MPE720 improvement item and bug fix change

Items added and features improved from MPE720 version 5.35 to version 5.36 are as follows.

No.2 Allocation number extension of serial port of communication process

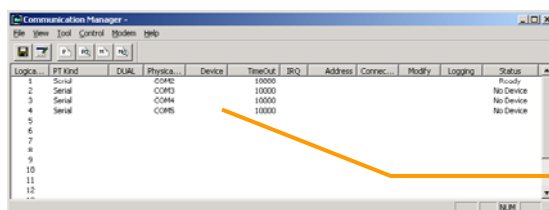
These were able to be allocated up to four though serial ports were able to be allocated to the port in the communication process only up to two at the same time up to now.

Serial can be allocated up to four at the same time.

No.3 Communication process COM port number extension

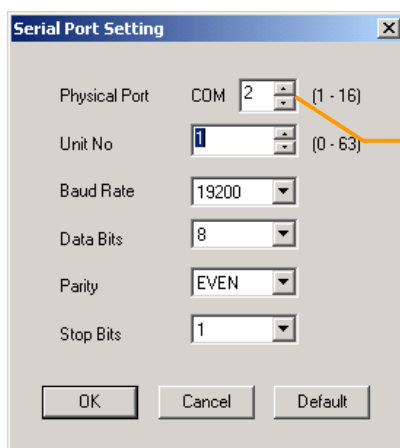
Because the number of use COM ports increased with USB-serial converter etc, the COM port number was able to be set even to the greatest 16 on the serial port casting off screen of the Communication process.

The selection of the COM port was extended to 1-16.

No.4 Motion parameter import export function

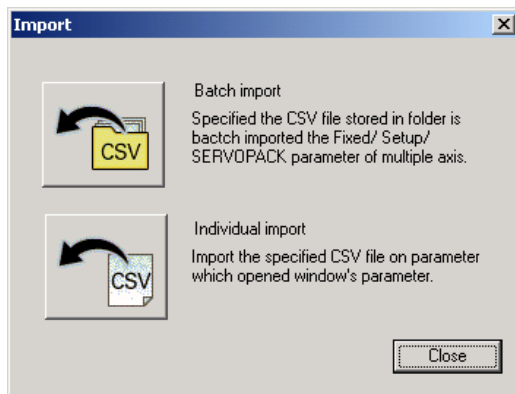
It was made importing of the fixed parameter, the configuration parameter, and the servo parameter of the MP2000 series by Comma Separated Value, and to export.

Managing the motion parameter that was able to be managed only by each PLC folder by Comma Separated Value according to this function becomes possible. As a result, a certain shaft parameter is reflected in plural shafts, and preserving the set point of the motion parameter by Comma Separated Value becomes possible.

No.5 Print system chart

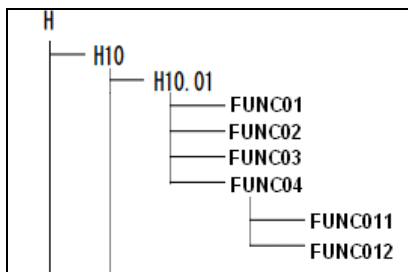
When the print was executed, the function to read the dependence in the user function drawing and to print the system chart was made.

No.6 For ****SERVO (MECHATROLINK module)

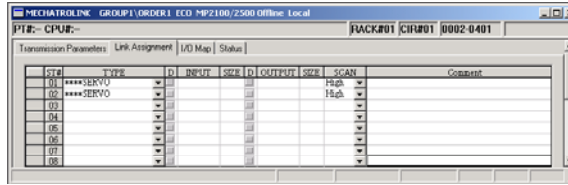
**** SERVO module of a possible casting off was added as a general-purpose MECHATROLINK servo. As a result, it ..MECHATROLINK servo made of third party becomes a possible casting off.

****SERVO doesn't have the servo parameter.

No.7 Transferring message improvement

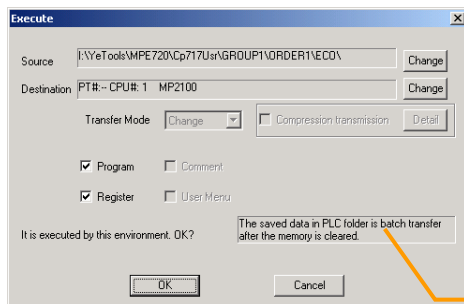
The message concerning each transferring operation was displayed on the all transfer and the individual transfer screen.

The transferring operation explanation of the object is displayed.

No.8 For communication process gateway function

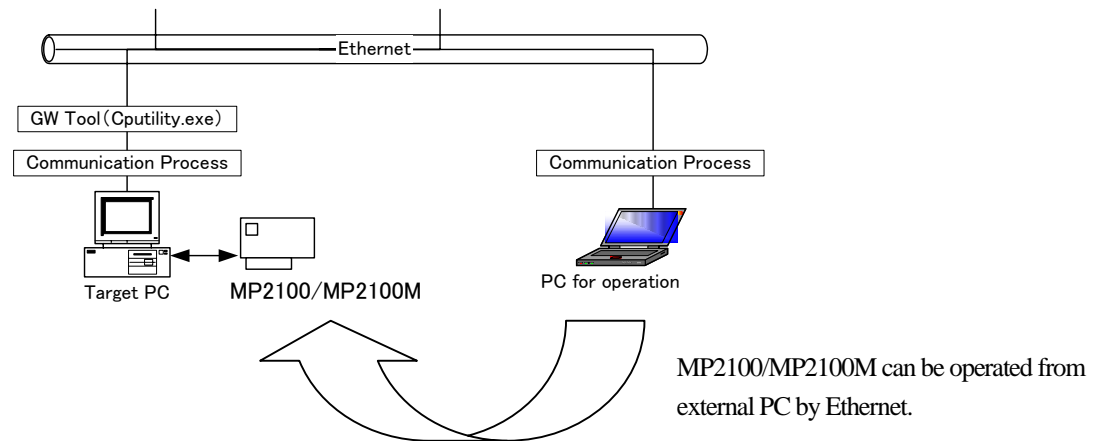
MP2100/ MP2100M being attached from an outside MPE720 to PC through Ethernet when PC that uses MP2100/ MP2100M has Ethernet port and doing in engineering directly become possible.
